P-14297

14537

ISSUE-2 :-

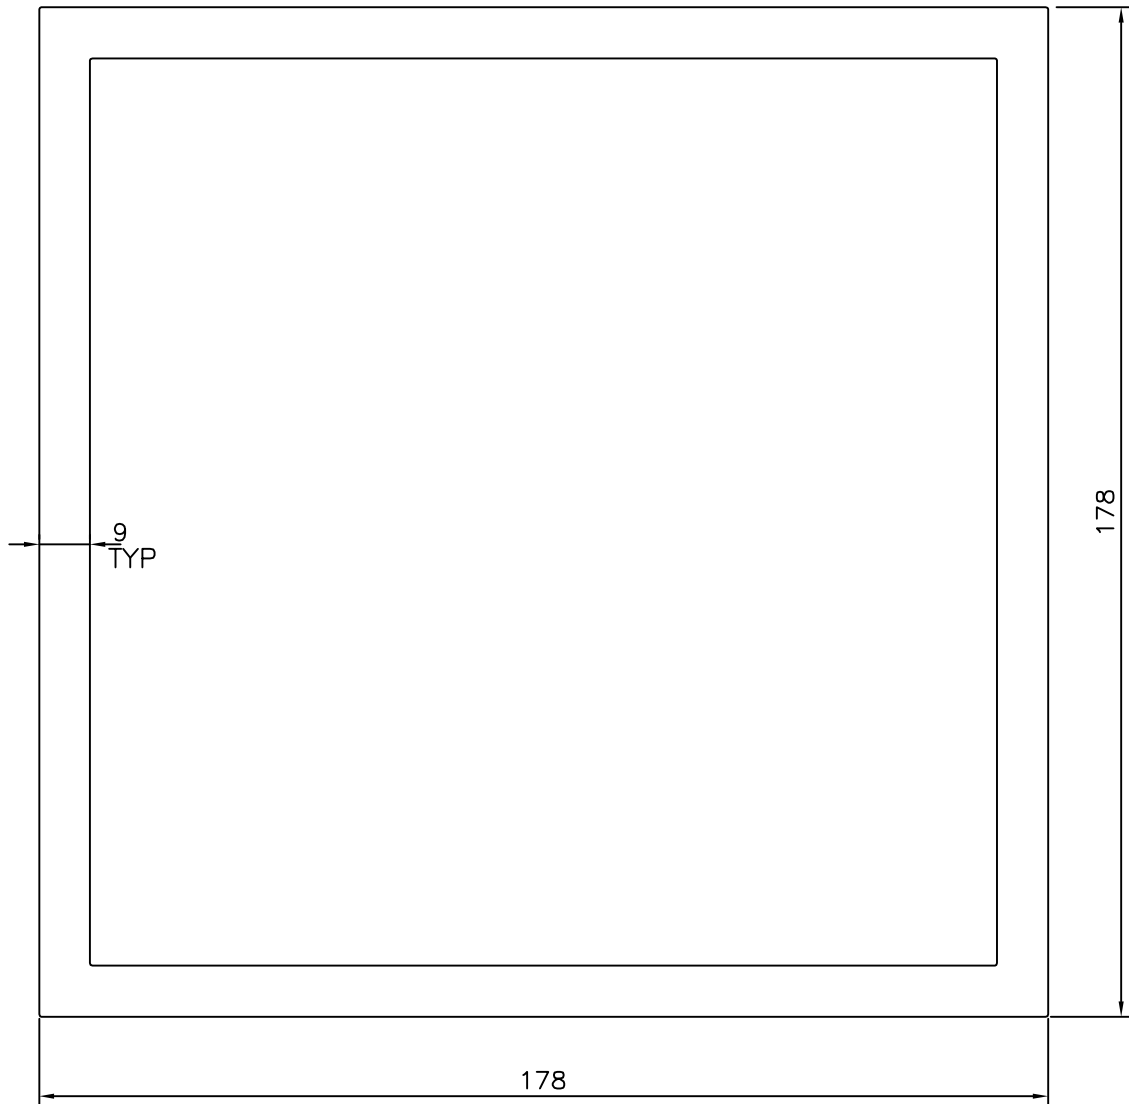
SIZE CHANGED FROM 180 TO 178 mm & THICKNESS CHANGED 10 mm TO 9mm

WEIGHT ALSO CHANGED FROM 18.360 TO 16.427 kg/M
